DELEGATED APPLICATION REPORT

App Ref: 220121/FUL

Address: "Land to the Rear of", 12-14 Wantage Road, Reading, RG30 2SE

Proposals: Erection of 2 x 2-bed semi-detached dwellings to the rear of No's 12 & 14 Wantage Road (fronting Wilson Road) and associated works, following demolition of existing structures.

Proposed streetscene elevation submitted by applicant

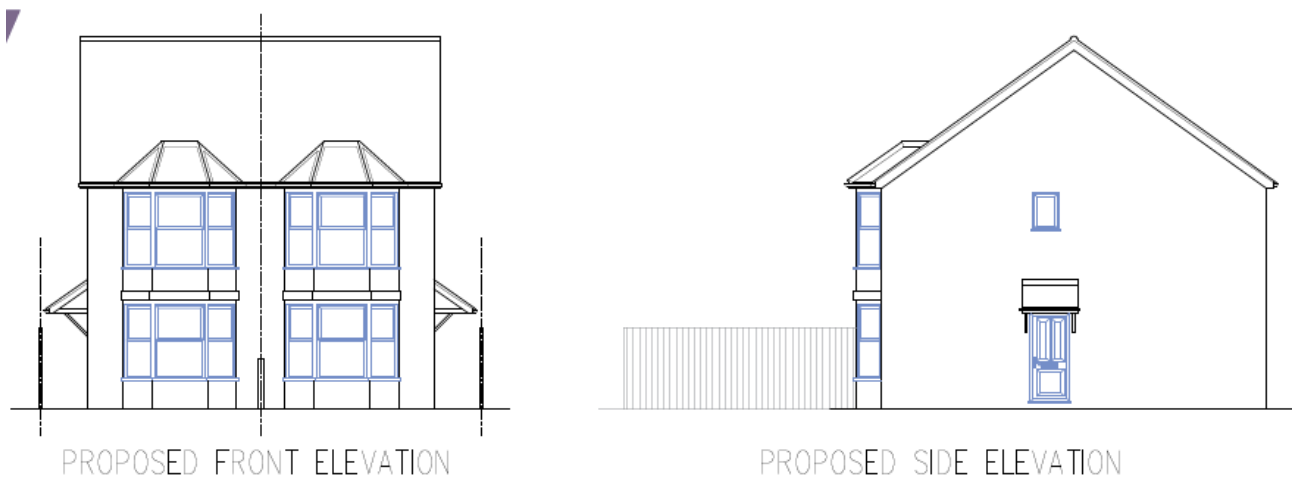
- 6.10 The proposed development would by its very nature be a visually prominent addition along the streetscene. The open character of this part of Wilson Road would be disrupted by the proposed development, with this exacerbated by the extent to which the proposed building projects into the plot (i.e. the depth of the dwellings). Given that the current openness is considered to form a valuable contribution to the overall character of this section of Wilson Road, the proposed development would visually jar with the long-established character and, in addition, the proposed footprint of development would represent an overdevelopment of the site. The proposed development would contrast sharply and negatively with the immediate neighbouring and nearby context along this part of the east side of Wilson Road, thereby failing to make a positive contribution to the character of the area. Instead, the impact of the proposed development would be harmful to the character and appearance of the area. The proposal is therefore contrary to Policies CC7 (Design and the Public Realm), H2 (Density and Mix) and H11 (Development of Private Residential Gardens of the Reading Borough Local Plan (2019).

Proposed front and (south) side elevation plans

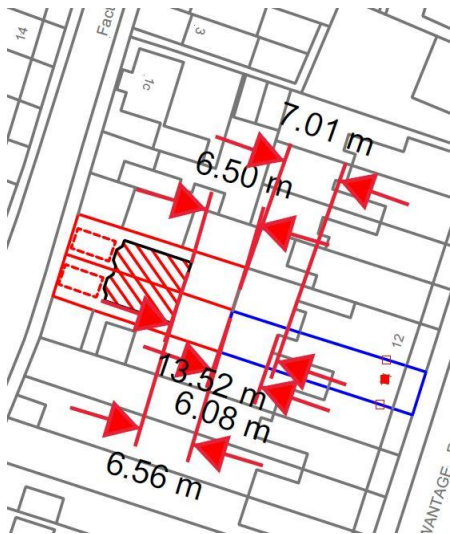
- 6.11 At the more detailed design level, the applicant's supporting commentary states "Our proposal is to blend within the characteristics of the east of Wilson Road. The appearance of the new concept is sympathetic to the area, retaining a ground floor bay window as per the surrounding properties. The roof structure also to be a gable end within keeping of the Victorian façade that is Wilson Road". The application form clarifies proposed materials as red facing bricks, slate tiles, PVC windows and timber fencing. In response, the proposed design is seeking to maintain the character and appearance of the area. In order to enhance it (as required by Policy CC7) it is considered that detailing within the brickwork (e.g. patterned brickwork, characteristic of the area) and design details such as windows lintels would be necessary. Had the proposals been supported at officer level, discussions in these regards would have been undertaken with the applicant, to seek to secure a level of design quality which enhances the character and appearance of the area, rather than the current level of detailing which would only maintain the quality. The provision of timber more traditional timber windows, rather than PVC specified, would be another area for discussion with the applicant. Ultimately, such detailing could have been secured via condition in the event of the application being acceptable and, therefore, this does not form a specific component part of the reason for the refusal of the application.

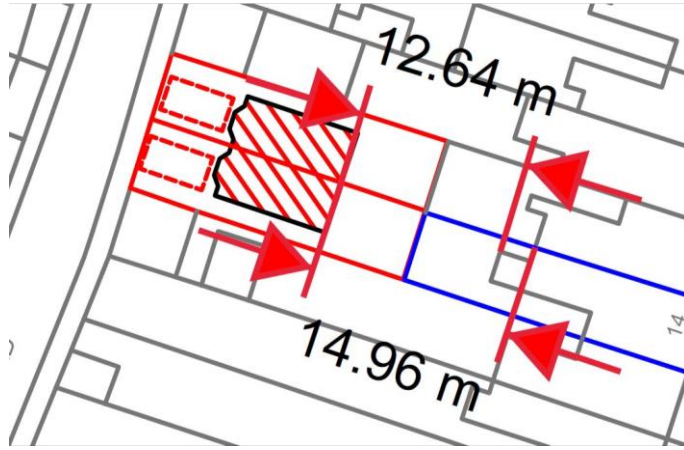
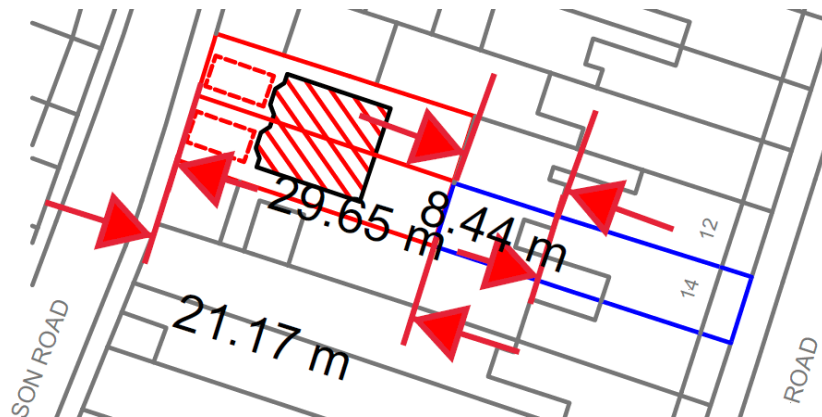
12.64m between ground floor levels (closest points)
14.96m between first floor elements (closest points)

29.65m between rear building line of No's 12 & 14 (excluding small single storey projections) to Wilson Road pavement (i.e. the depth of the existing rear amenity space)
21.17m depth of the proposed dwellings
8.44m depth of remodelled rear amenity spaces for existing No's 12 & 14 Wantage Road (excluding small single storey projections) to the boundary with the proposed dwellings
*Given this is based on the site location plan (1:1250) there is a degree of non-precision in the figures/measurements.
